Amendments to the Drawings:

Amended Figures 6, 10 to 12, 14, 17, 25 and 26 enclosed.

In response to the Examiner's first Office Action of November 29, 2005 the Applicant respectfully submits the accompanying Amendment to the specification, drawings and claims, and the below Remarks.

FIG. 25

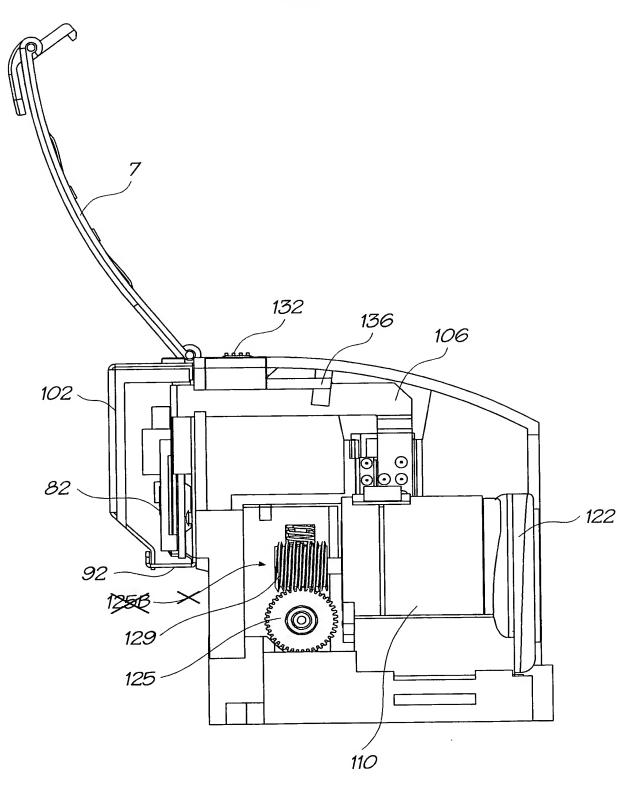
at page 13, lines 13-16 of the present specification "127" is omitted from "drive shaft of motor 110" and "125B" is replaced with --125-- when referring to the cog fixed to the drive roller 96, which is illustrated in Figure 25 of the present application;

Figure 25 is amended to omit reference character "125B";
